Global Change Notification (GCN)

Product Family External MiniSAS cable assem 10619145

Series 74547 December 24, 2013

Reason For Change Product Component Change

Datecode on the PCB

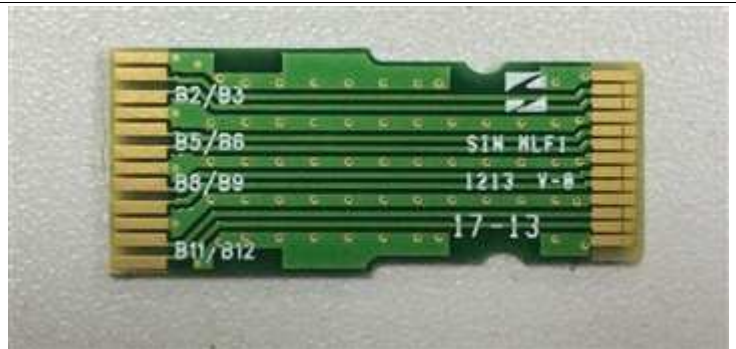
Method of Identifying Change Date code as below picture
